CITY OF ANGLETON
PLANNING AND ZONING COMMISSION AGENDA
120 S. CHENANGO STREET, ANGLETON, TEXAS 77515
THURSDAY, DECEMBER 02, 2021 AT 12:00 PM

Re: On-Going Services
Plat and Plan Review of Kiber Reserve Ph. 2 Subdivision – 1st Submittal Review
Angleton, Texas
HDR Job No. 20-007

HDR Engineering, Inc. (HDR) has reviewed the plat and plans for the above referenced property and offers the following comments:

GRADING PLAN

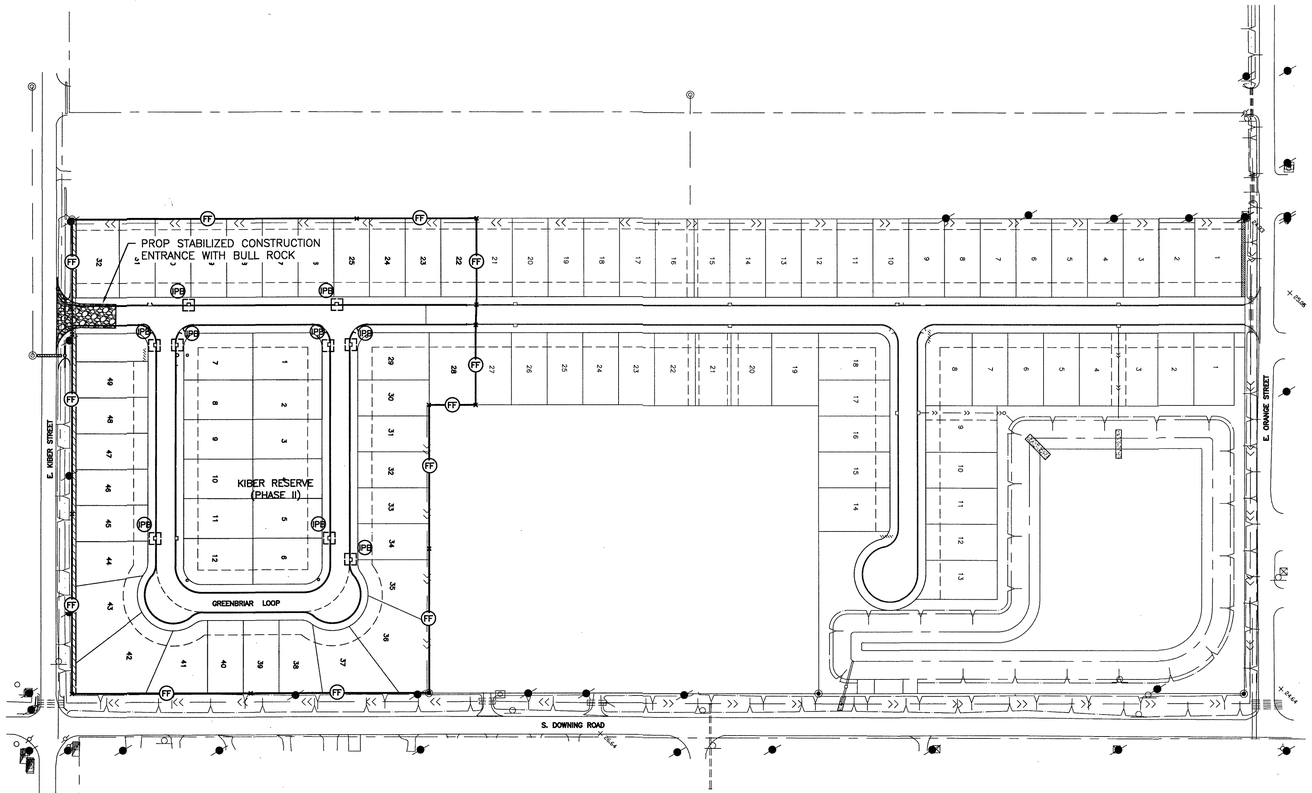
13. Show drainage easement on plat and plans for the "V" swale shown along the property line near the existing 5.00 acre tract.
14. Verify finished floor elevations for Phase 2 and update note shown.
15. Verify proposed elevations shown at the ditch along Downing Road and remove if no longer needed.
16. For the cross-section details noted on the sheet, include the reference locations on the plan drawing.
